Attachment 1
NRC3-13-0036

NRC Action Item 3.7-12

Markup of Fermi 3 COLA

Figure 3.7.1-251 Normalized Arias Intensity and Estimates of Equivalent Stationary Duration for Calculating the PSD for the Spectrally Matched Horizontal (H1 and H2) Components Compatible with the Fermi 3 RB/FB Enhanced SCOR FIRS

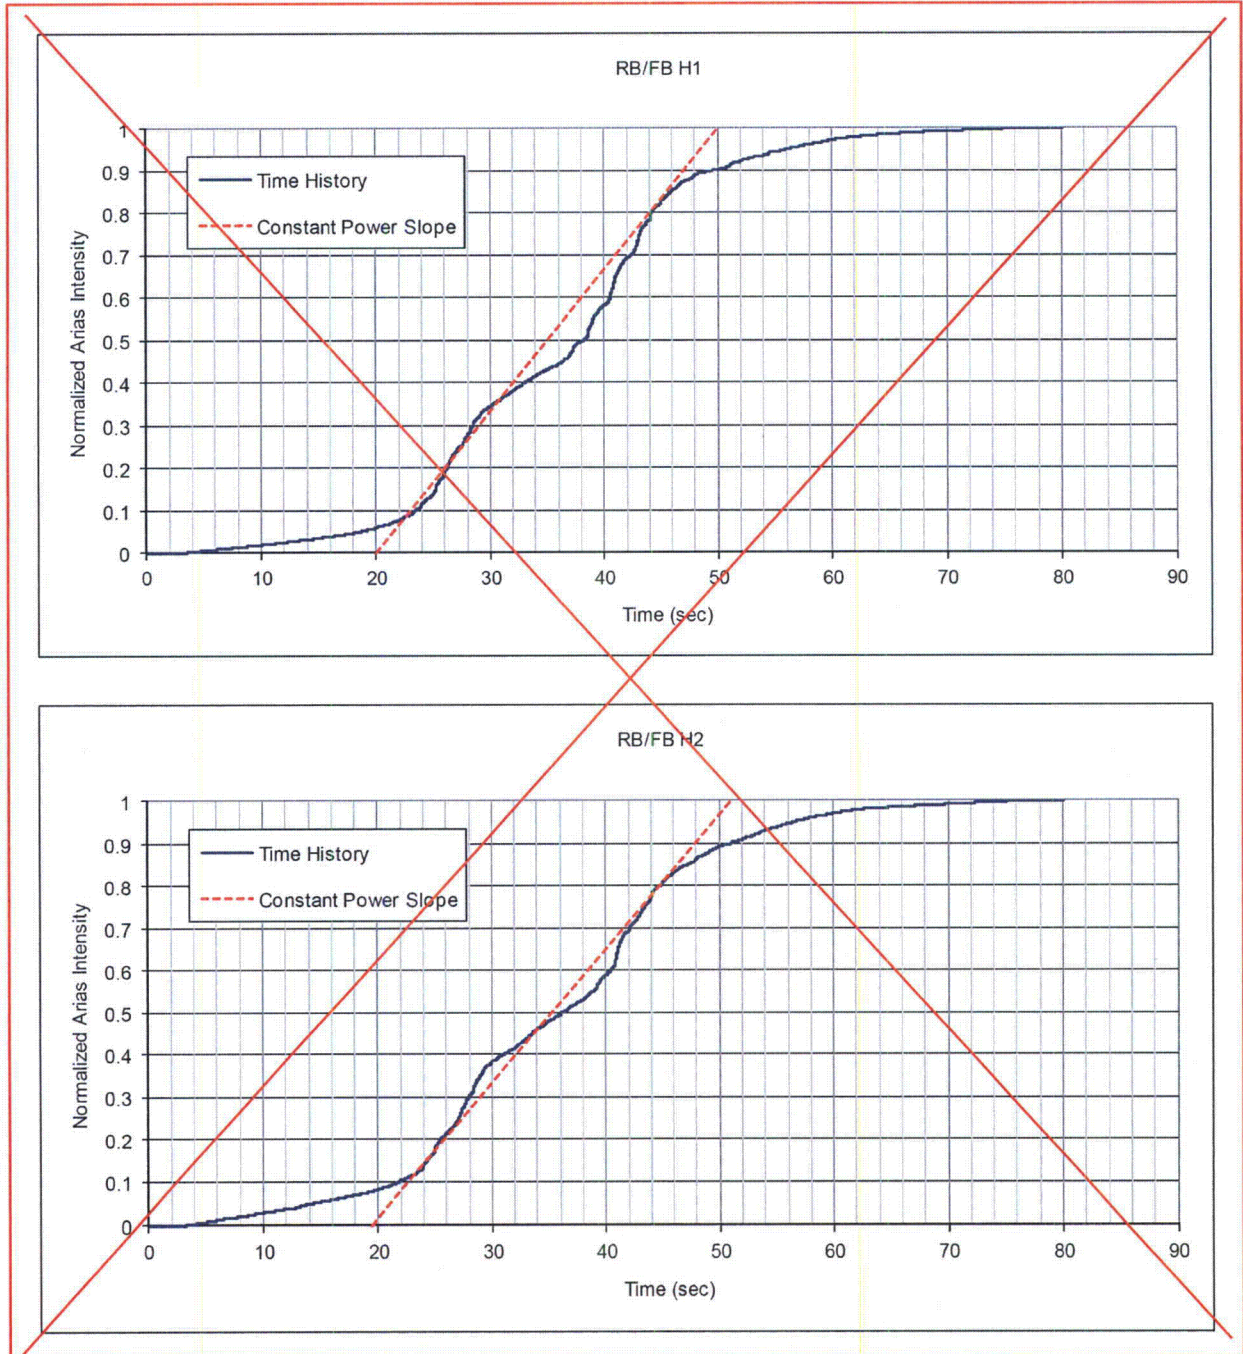
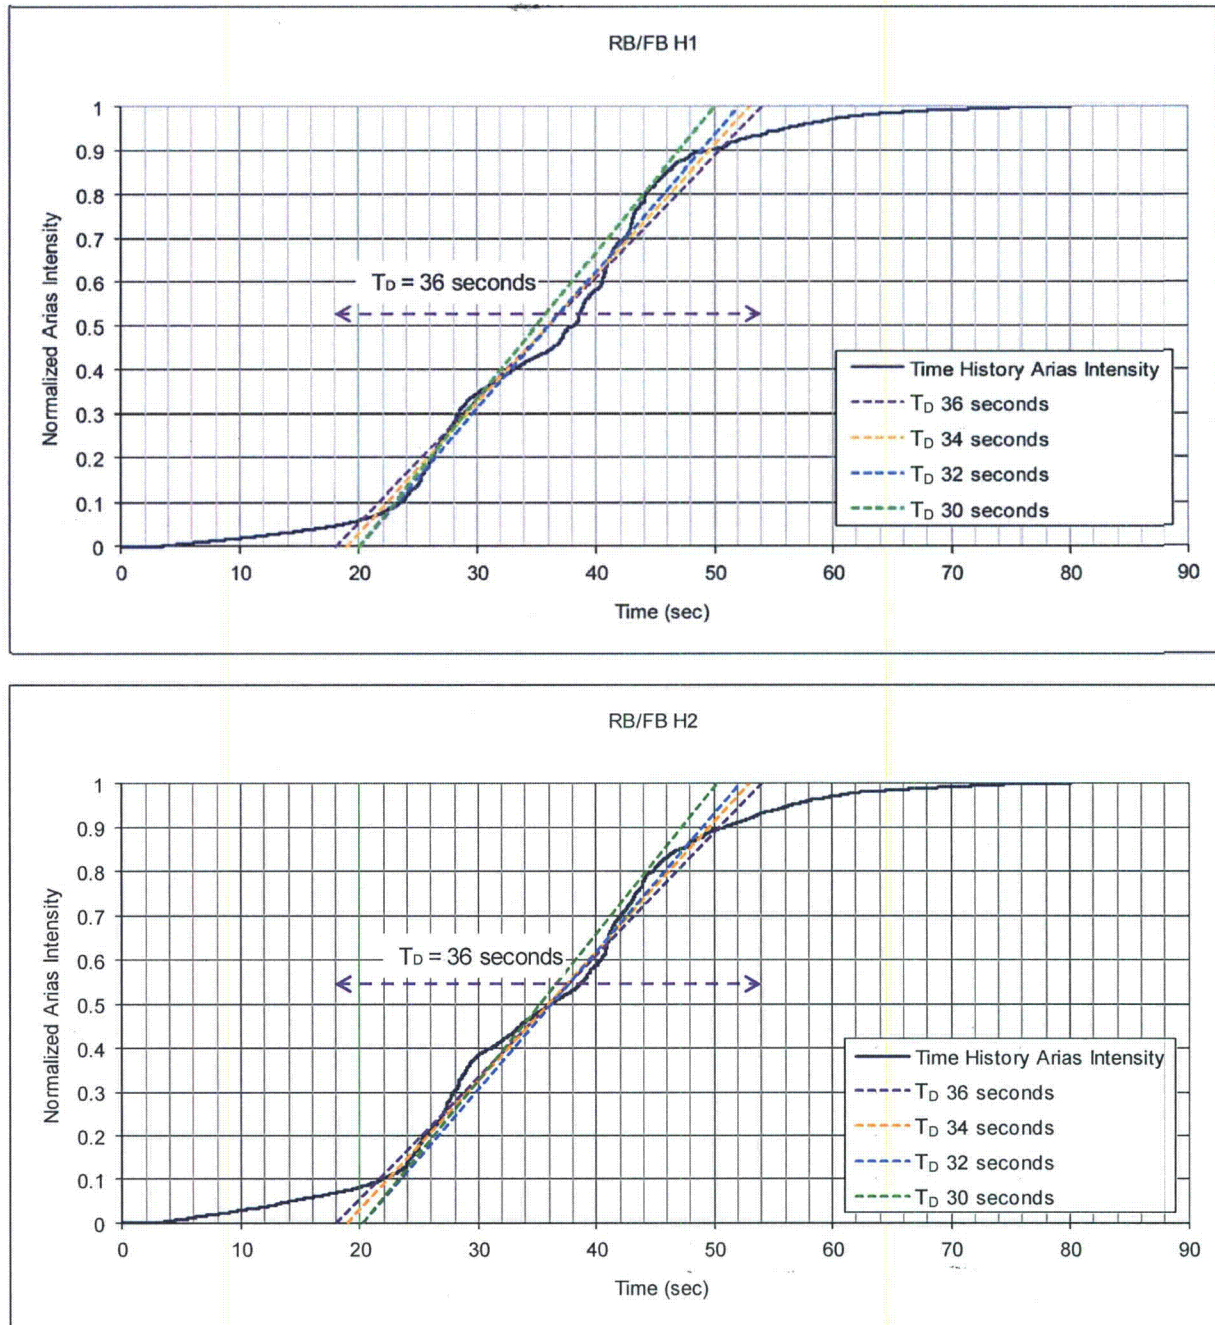
Response

To demonstrate that there are no significant gaps in power for the spectrally-matched time histories, power spectral densities (PSD) were calculated for the frequency range of 0.3 to 50 Hz following the guidance in SRP 3.7.1, Appendix B. The equivalent stationary duration, T_D , used to calculate the PSD for the spectrally-matched time histories was established in general accordance with SRP 3.7.1 and the additional guidance in NUREG/CR-5347 (Reference 3.7.1-221). Figure 3.7.1-251 presents the normalized Arias intensities for the horizontal components, H1 and H2, of the spectrally matched time histories compatible with the RB/FB enhanced SCOR FIRS. The normalized Arias intensity plots for the spectrally matched time histories compatible with the CB enhanced SCOR FIRS are not presented since they are essentially identical to Figure 3.7.1-251.

Appendix B of NUREG/CR-5347 (Reference 3.7.1-221) indicates that T_D is estimated by identifying the portion of the time history where the slope (power) of a cumulative energy plot (represented by normalized Arias intensity) is nearly constant and near maximum. Figure 3.7.1-251 provides a range of estimates of constant power slopes for the two horizontal RB/FB components.

Figure 92: Comparison of horizontal oscillator 99981 RS and ESBWR standard plant enveloping RS for north-south direction (input motion from node 109).

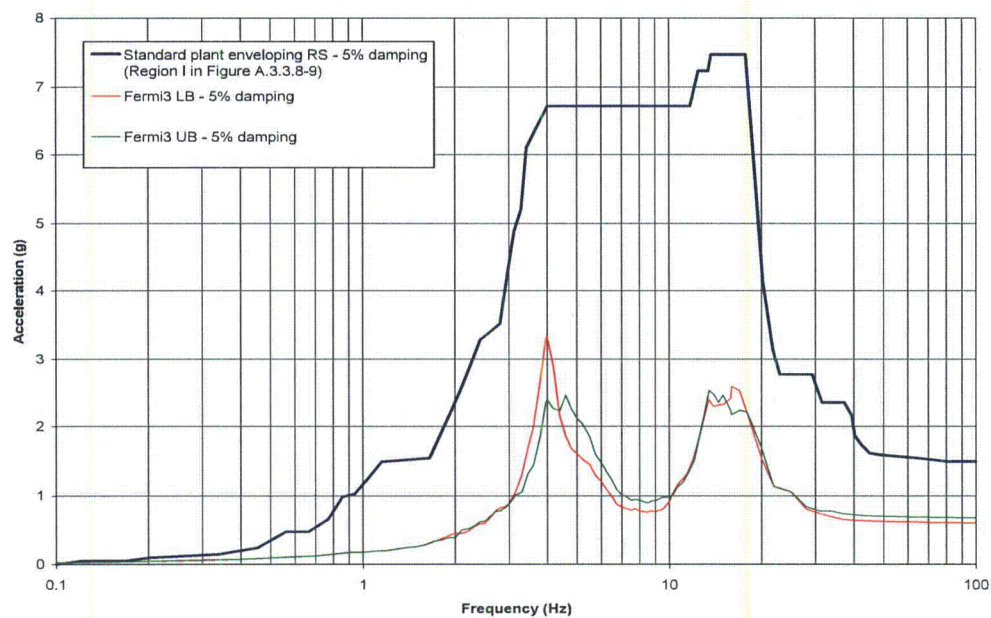
Attached Figures 92 through 96 show the comparisons between the 5% damped oscillators' response spectra from Node 109 input and the corresponding Standard Plant enveloping response spectra for the applicable wall region. Attached Figures 97 through 101 show the comparisons between the 5% damped oscillators' response spectra from Node 110 and the corresponding Standard Plant enveloping response spectra for the applicable wall region. Since for the layered soil conditions, ESBWR DCD has used Case RL-6 with cracked wall out-of-plane (ESBWR DCD Table 3A.6-1), layered Fermi 3 (with engineered granular backfill described in Reference 5) is used in developing these oscillator spectra. The oscillator damping used is 7%, consistent with the DCD damping for the concrete cracked case. The input motions for the oscillators are from building a model with 4% structural damping (analyses described in Reference 5), resulting in conservative oscillator response spectra.

The spectra comparisons in Figures 92 through 101 show that the standard plant enveloping oscillator response spectra bound the site specific Fermi 3 oscillator response spectra by a large margin, except in Figure 93, where the seismic input from Node 109 produces Node 99982 oscillator spectral value almost same as the standard plant enveloping oscillator response spectra. Since Node 99982 oscillator is located between Node 109 and Node 110, the response spectra at Node 99982 will be in-between the response spectra from Node 109 input and Node 110 input. Thus the spectra for this oscillator will also be bounded by the standard plant enveloping oscillator response spectra. Figures 102 and 103 on which response spectra at node 99982 from Node 109 input and Node 110 input are plotted on the same sheet (one sheet for LB case and one sheet for UB case) are provided to help visualize where the actual response would lie.
